CHANGES AND ADDITIONS  
TO BULLETINS 1108B (ISSUE 2) AND 1126B (ISSUE 1)  
PARTS - REPERFORATOR TRANSMITTER (MODEL 14)

This correction sheet supersedes correction sheets 659EE, 692EE, and 741EE.

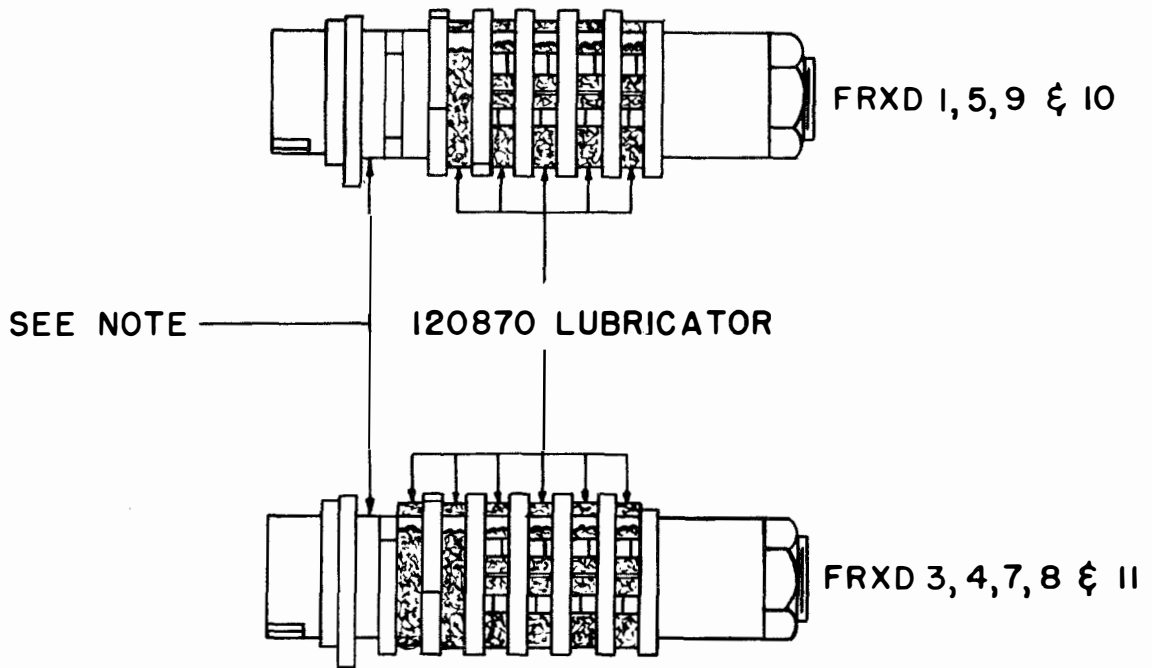
\*In the sensing contacts mounting parts the ten 7002 Washers have been replaced by ten 74722 Washers. Under the 102168 Post the 2191 Lock Washer has been omitted and the 7002 Washer has been replaced by a 74722 Washer (on Page 25 also in Bulletin 1108B). The 102089 Spacer - Long in the contact pileup has been replaced by a 102088 Spacer.

FIGURE 1

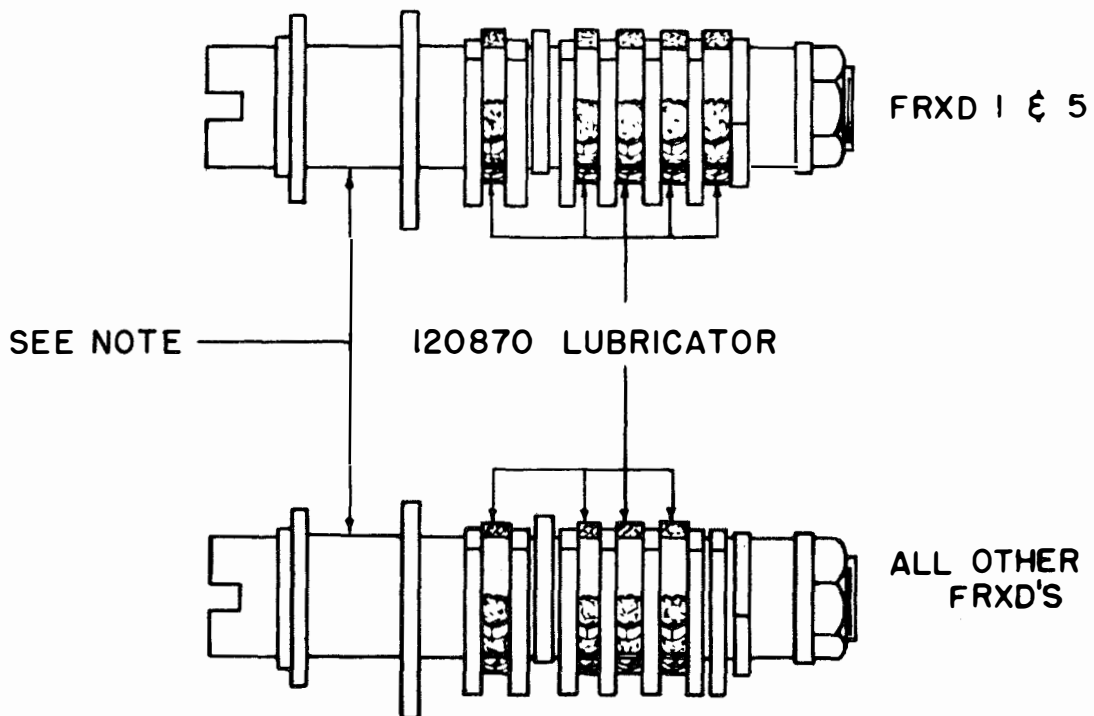
The 120870 Lubricators have been added to the sensing and distributor cam sleeves. See Figure 1 for parts.

FIGURE 2

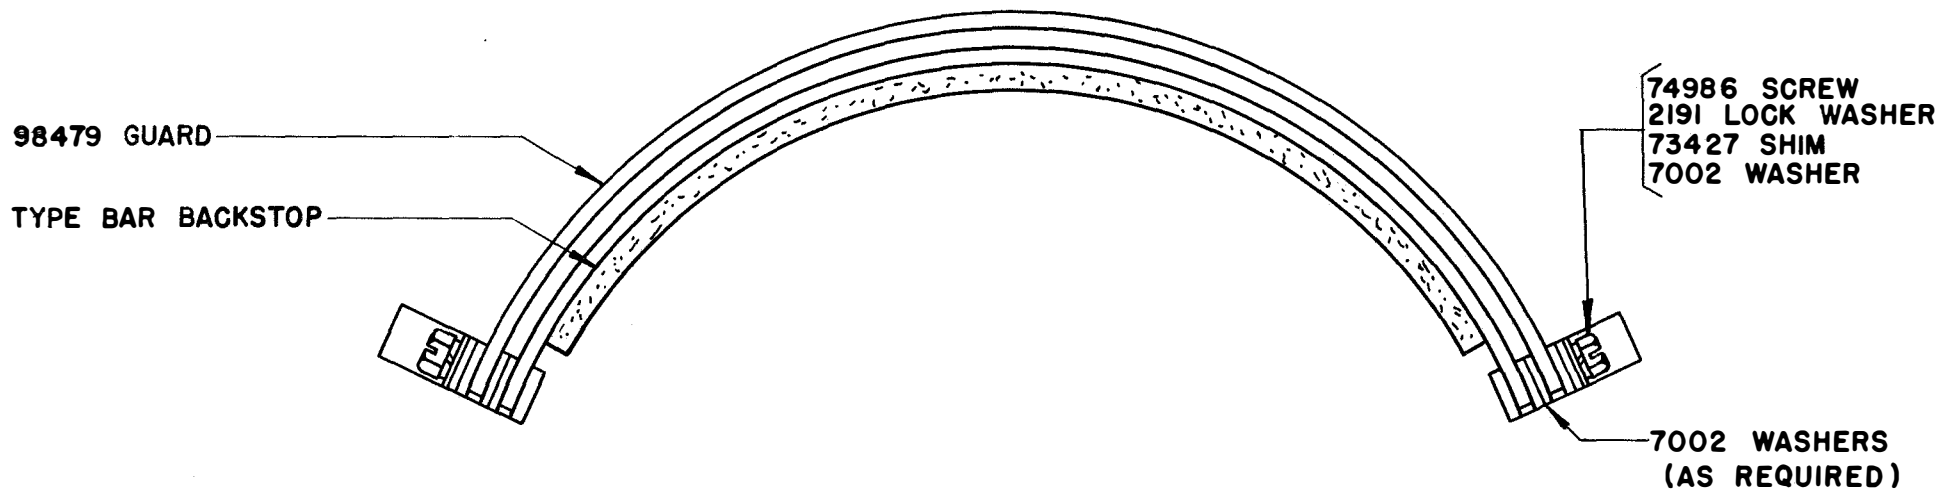
The 98479 Guard for the type bar backstop as shown in Figure 2, now applies to all models.

FIGURE 3

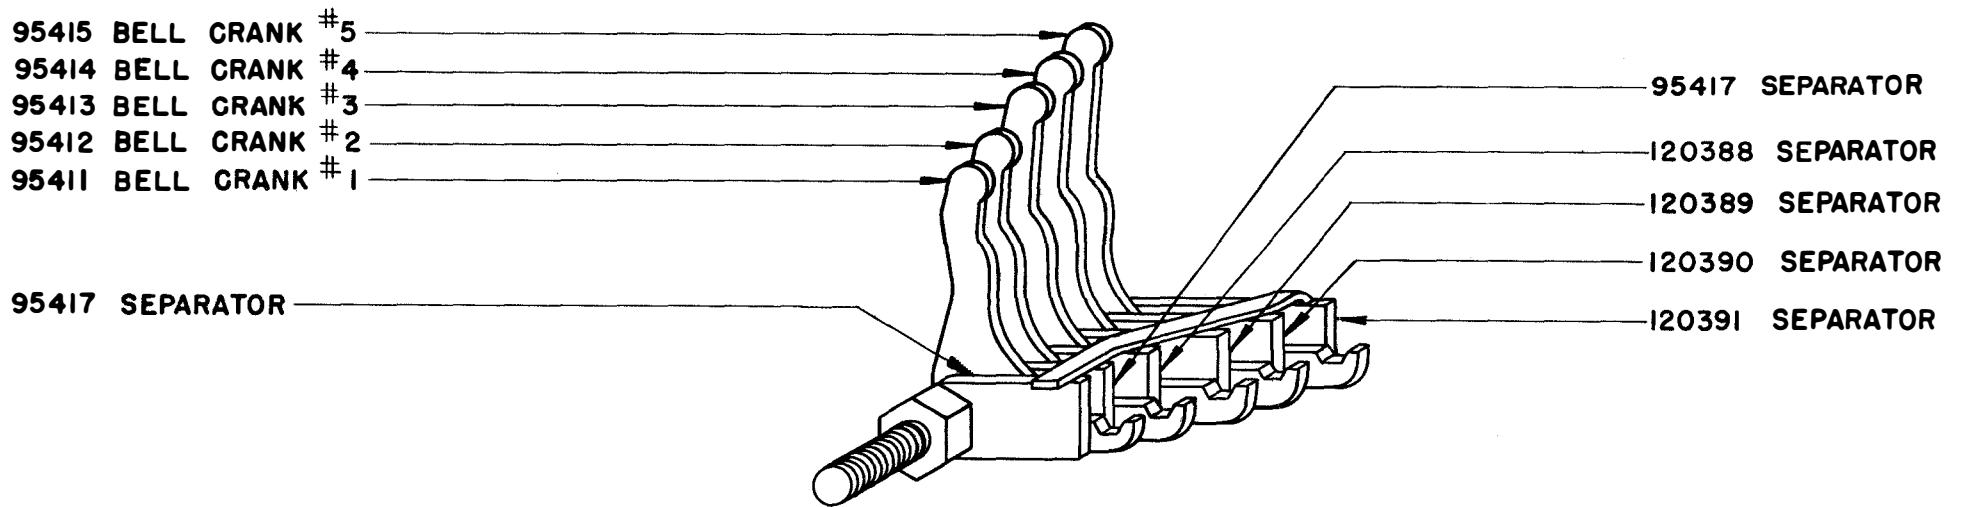
Four of the six 95417 Separators have been replaced by four separators of new design. See Figure 3 for parts. In the upper illustration, the 7603 Spring replaces the 115978 Spring in Bulletin 1108B and the 112634 Spring in Bulletin 1126B.

FIGURE 4

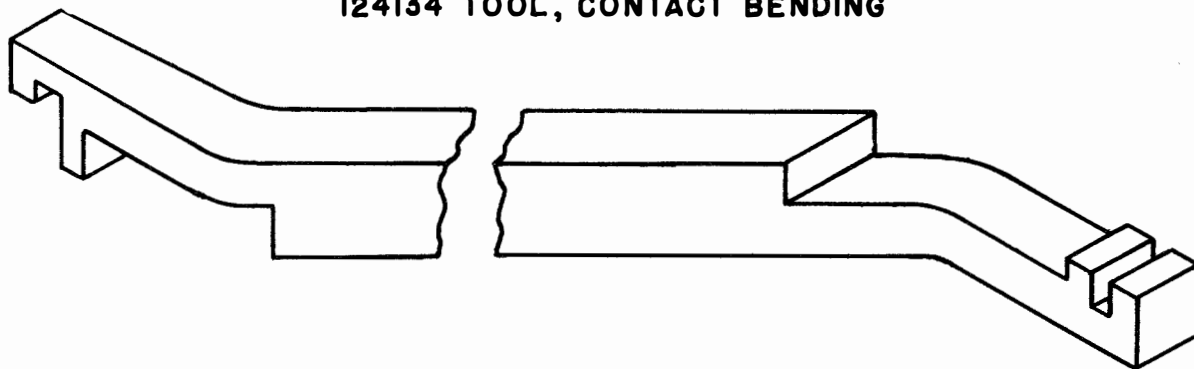
The 124134 Spring Bending Tool is recommended for adjusting the distributor contacts. See Figure 4.

FIGURE 5

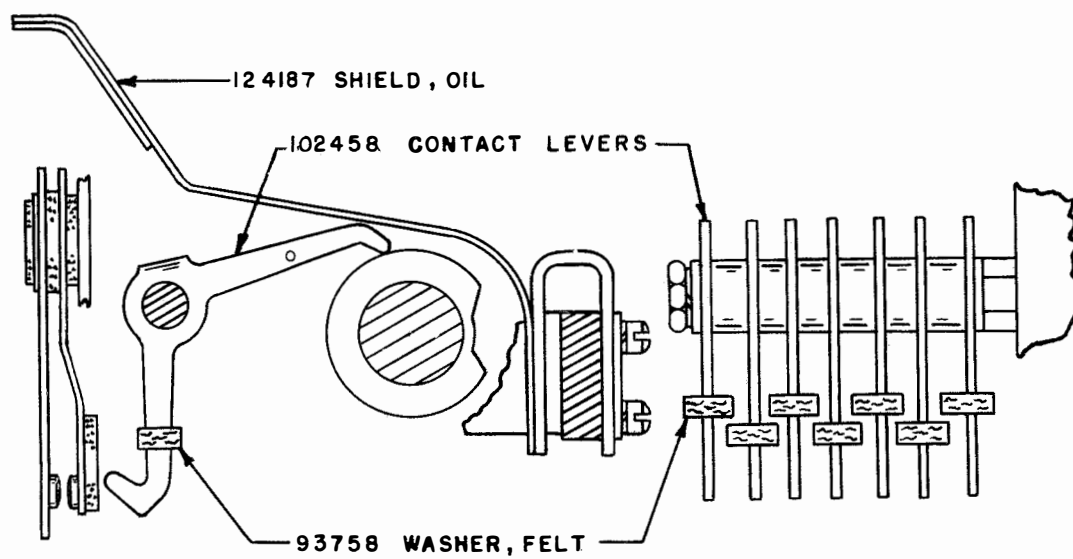
The 103516 Oil Shield for the distributor contacts has been replaced by a 124187 Oil Shield. (Figure 5).

The 93758 Washers have been added to each of the 102458 Contact Levers (as indicated in illustration) to absorb excess oil. (Figure 5).

FIGURE 6

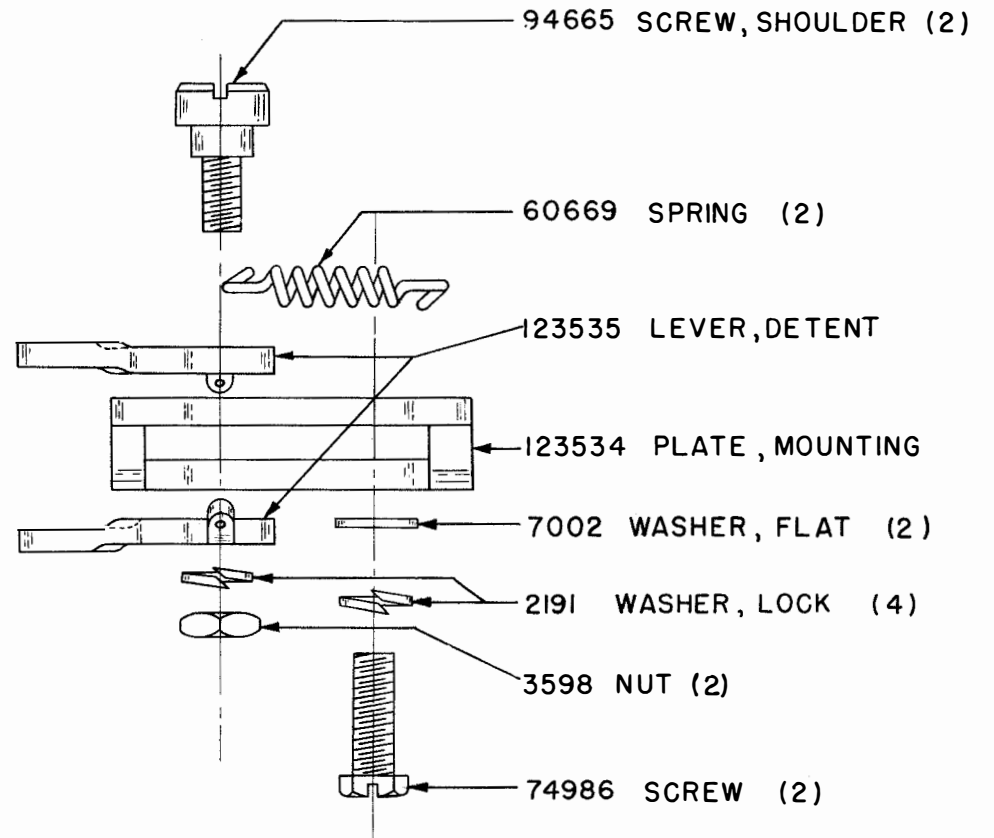
CLUTCH DETENT LEVER BRACKET AND TAPE-OUT CONTACT (ASSEM.) - The 115778 set of parts (Figure 6) replaces the following parts:

FIGURE 7

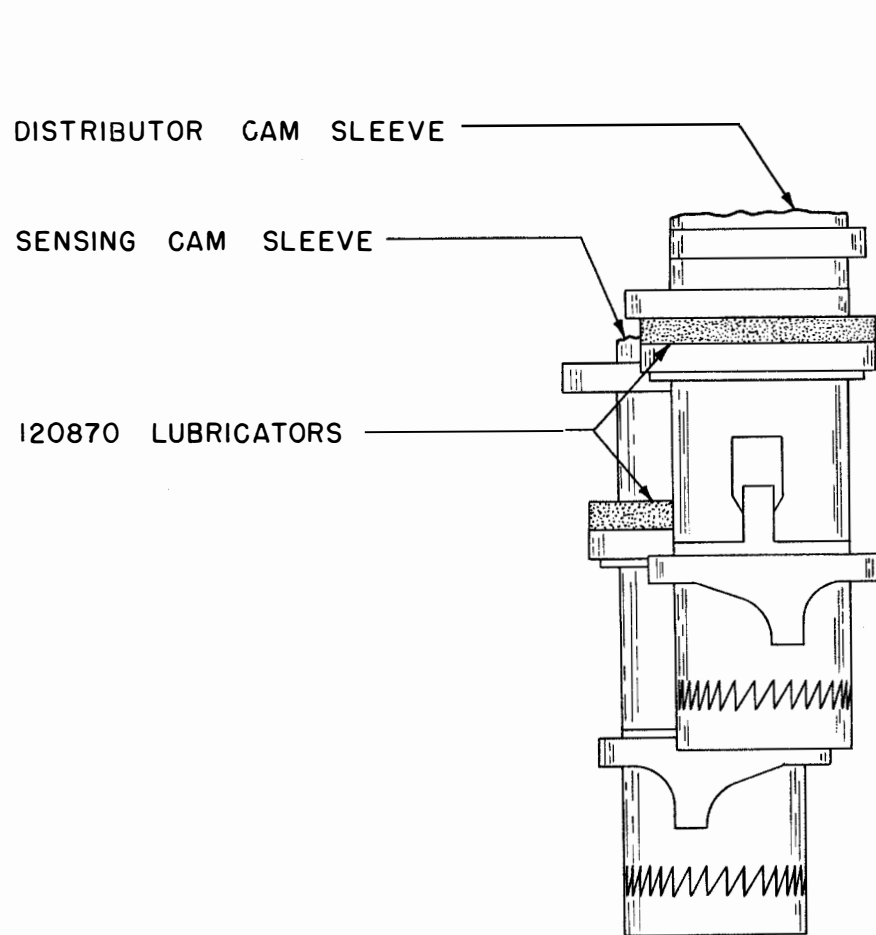
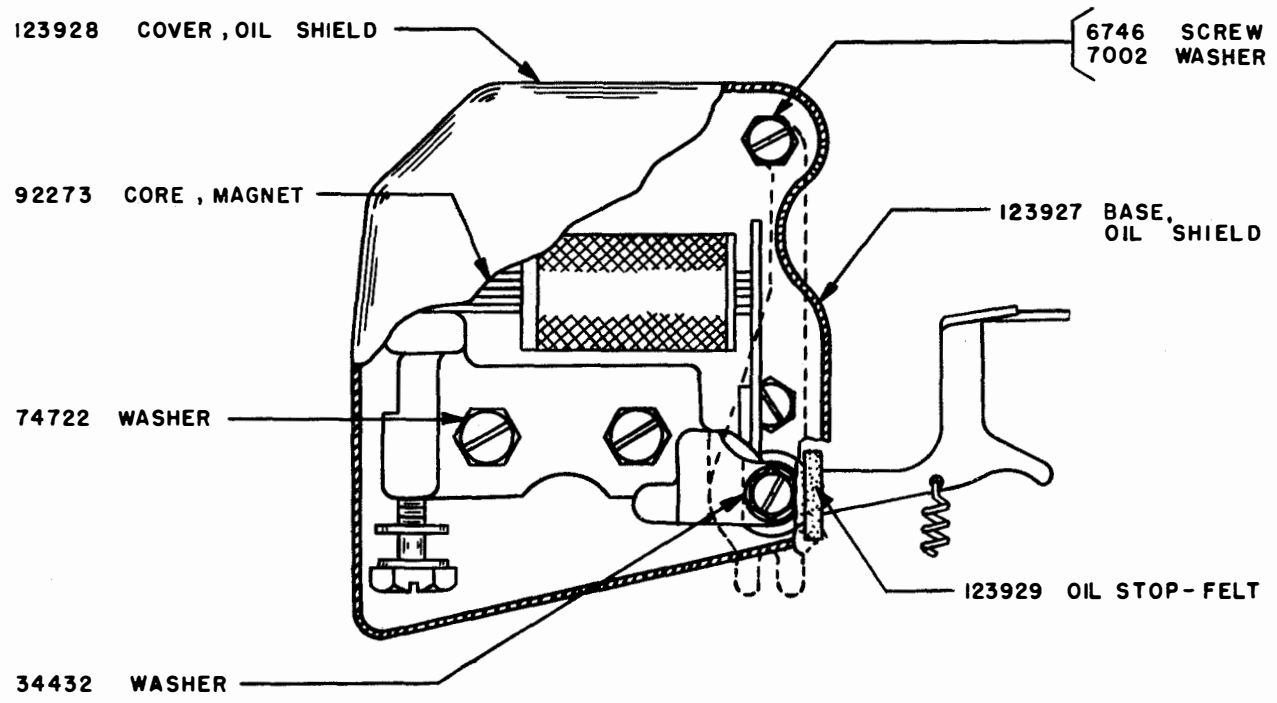
OIL SHIELD FOR SELECTOR MAGNET CORES - The 113693 Set of Parts (Figure 7) has been added to the holding magnet selector. New style 92273 Magnet Cores have a red spot on the rear surfaces for identification purposes.
